Access Compliance Report Public Rights-of-Way (Curb Ramps)

Intersection ID: 24825 Main Street: CHOATE_CR Cross Street: MOSS_RD Location: NE

ADA ID: AE379A9D667D Ramp Type: PerpDiag Initial Pass/Fail: Fail Overall Compliance: No Severity Score: 13.75

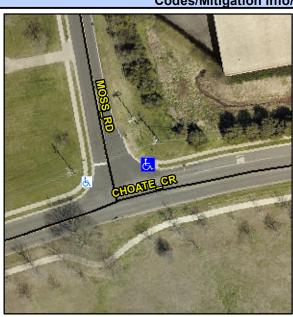
PROW/ADA:
Not Found, R304.2.2, R304.5.3

Field Measurements/Component Compliance					
Compliance Description		Data	Compliance Description		Data
N/A	Ramp Length (in)	48.0	No	Ramp Slope (%)	9.0
Yes	Ramp Width (in)	48.0	No	Ramp XSlope (%)	4.0
N/A	Flare Type LT	N/A	N/A	Flare Type RT	N/A
N/A	Flare Slope LT (%)	N/A	N/A	Flare Slope RT (%)	N/A
N/A	Flare Traversable LT?	N/A	N/A	Flare Traversable RT?	N/A
N/A	Landing Length (in)	N/A	N/A	DWS Provided?	N/A
N/A	Landing Width (in)	N/A	N/A	DWS Contrast?	N/A
N/A	Landing Slope (%)	N/A	N/A	DWS Length (in)	N/A
N/A	Landing X Slope (%)	N/A	N/A	DWS Full Width?	N/A
N/A	Landing Curb? (Y/N)	N/A	N/A	DWS Offset (in)	N/A
N/A	Shared Landing?	N/A			
N/A	Gutter Ponding?	N/A	N/A	Gutter Slope (%)	N/A
N/A	Gutter Lip Ht (in)	N/A	N/A	Gutter X Slope (%)	N/A
N/A	Painted X Walk1?	No	N/A	Painted X Walk2?	No
	X Walk 1 Direction	To W		X Walk 2 Direction	To S
N/A	X Walk 1 Width (in)	N/A	N/A	X Walk 2 Width (in)	N/A
	X Walk 1 Slope (%)	6.6		X Walk 2 Slope (%)	3.1

Remove & Replace Curb Ramp With
Two New Directional Ramps or
Equivalent.
